**KNOXVILLE HISTORIC ZONING COMMISSION  
STAFF REPORT - CERTIFICATE OF APPROPRIATENESS APPLICATION**

**PROPERTY LOCATION:** 2330 Jefferson Ave /  
Parcel ID 82 J T 011

**FILE NO.:** 6-B-19-HZ

**DISTRICT:** Edgewood-Park City H-1

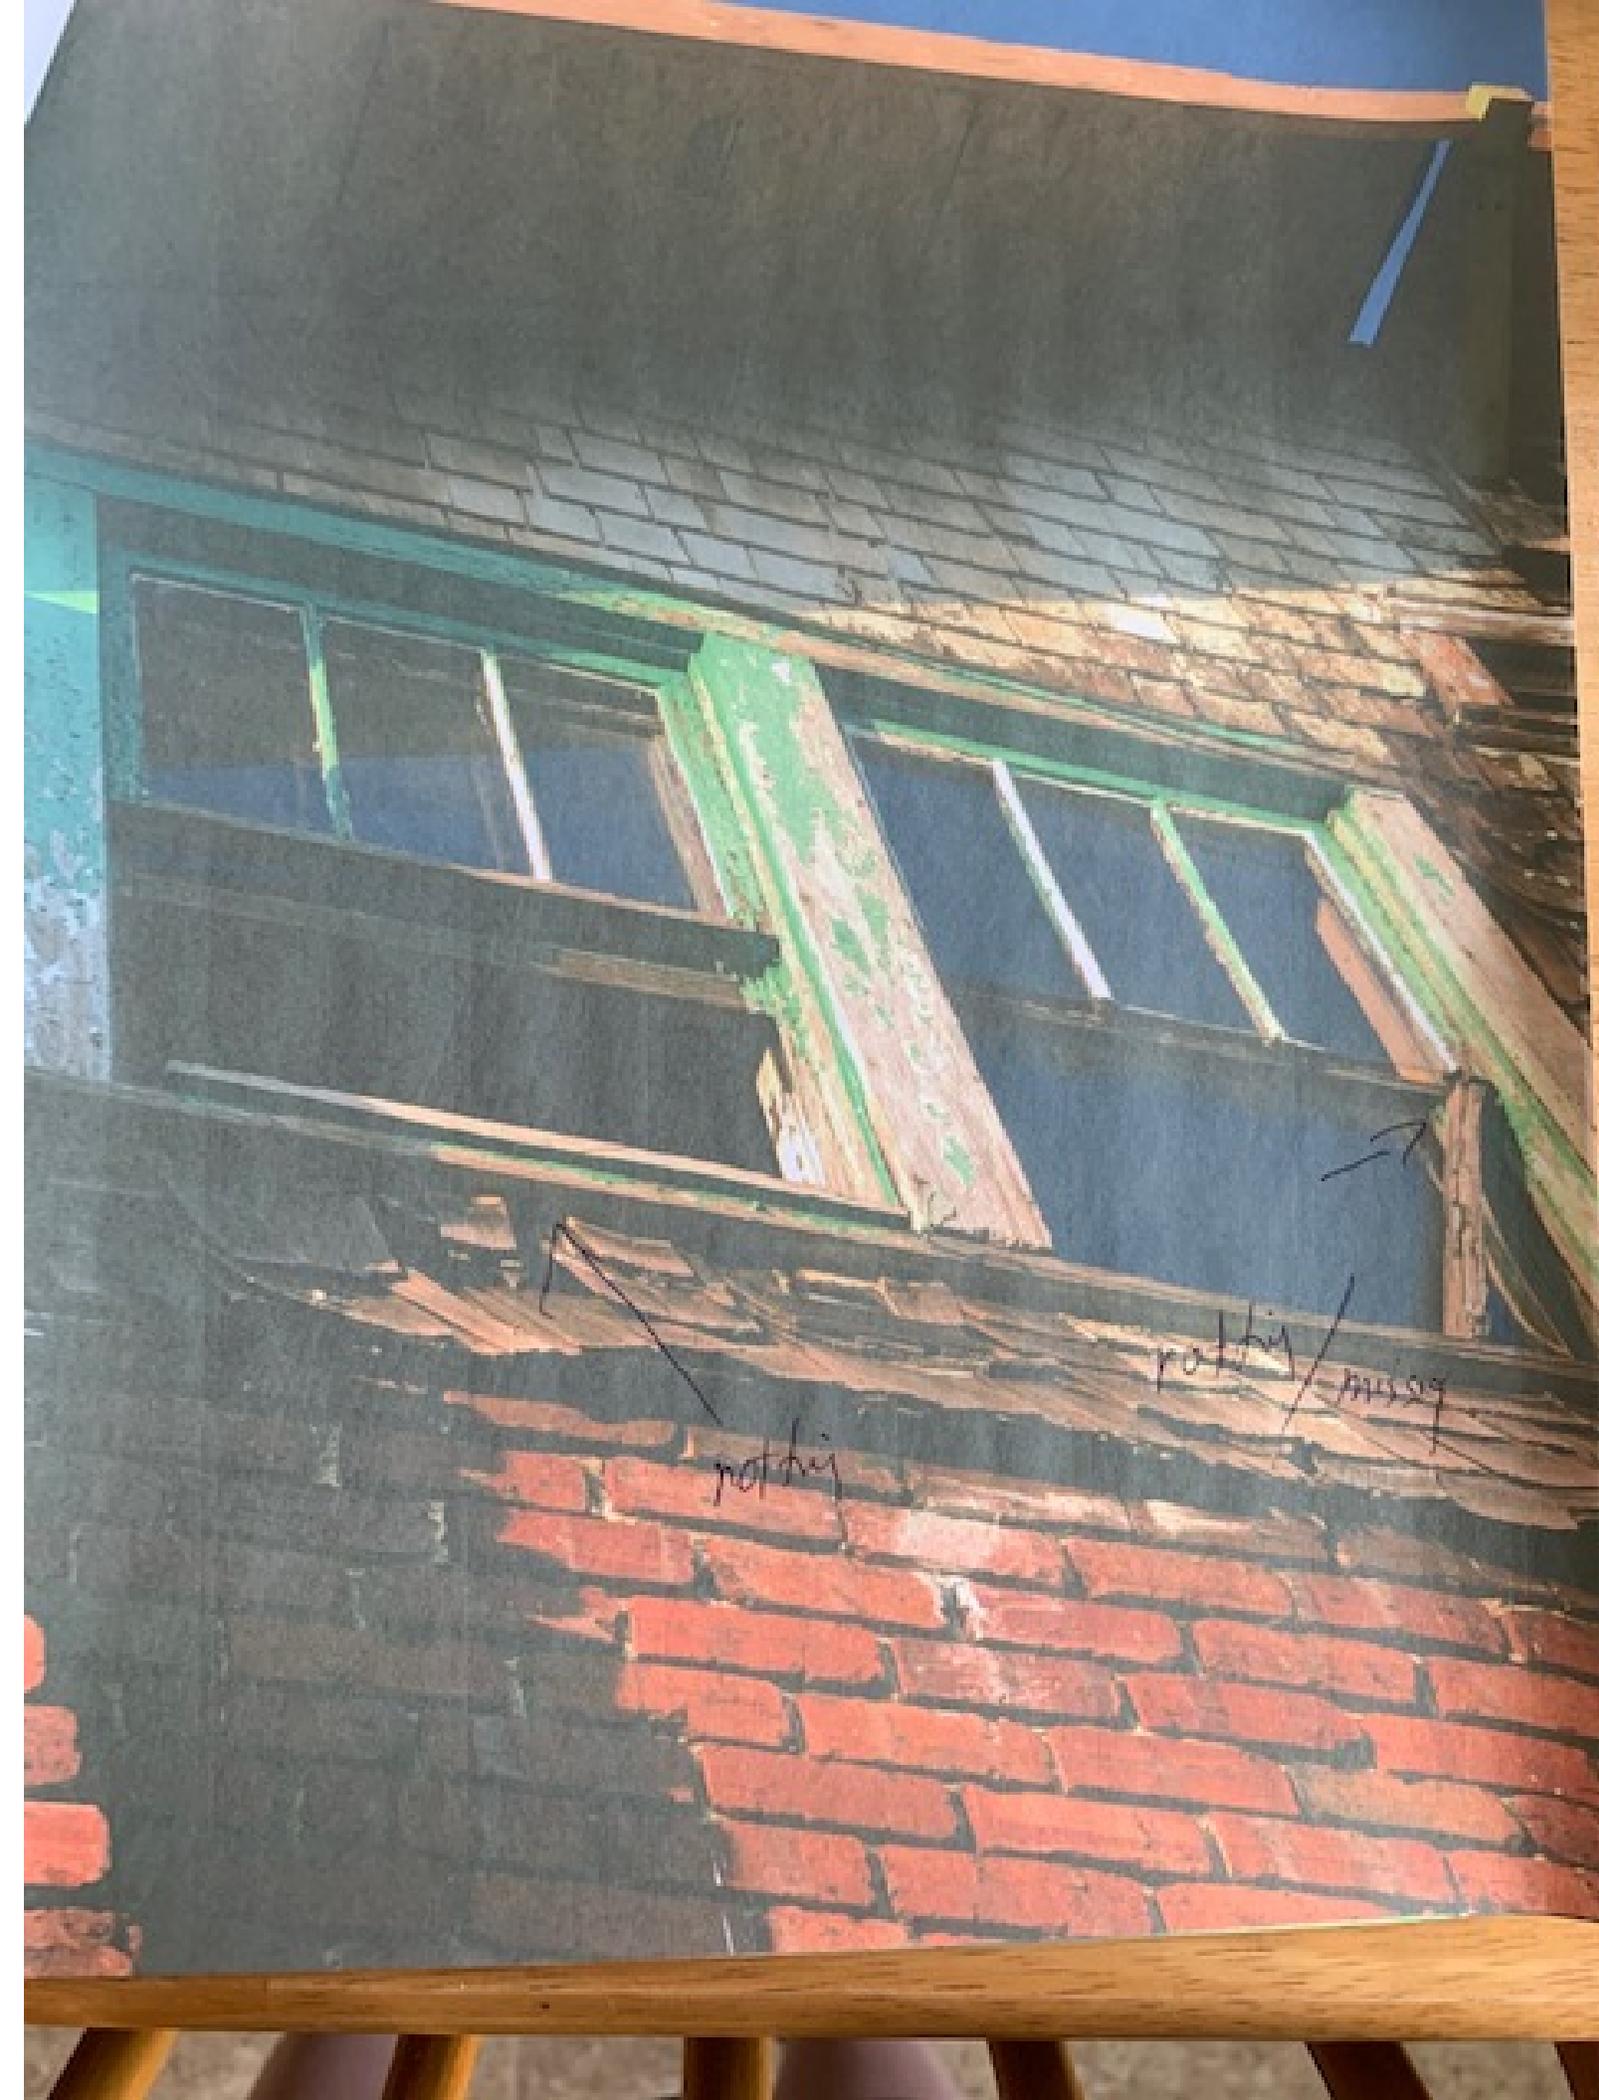
miss my  
stash

missing top  
stalk

rotting

rotting / missing

missy bottom  
stash
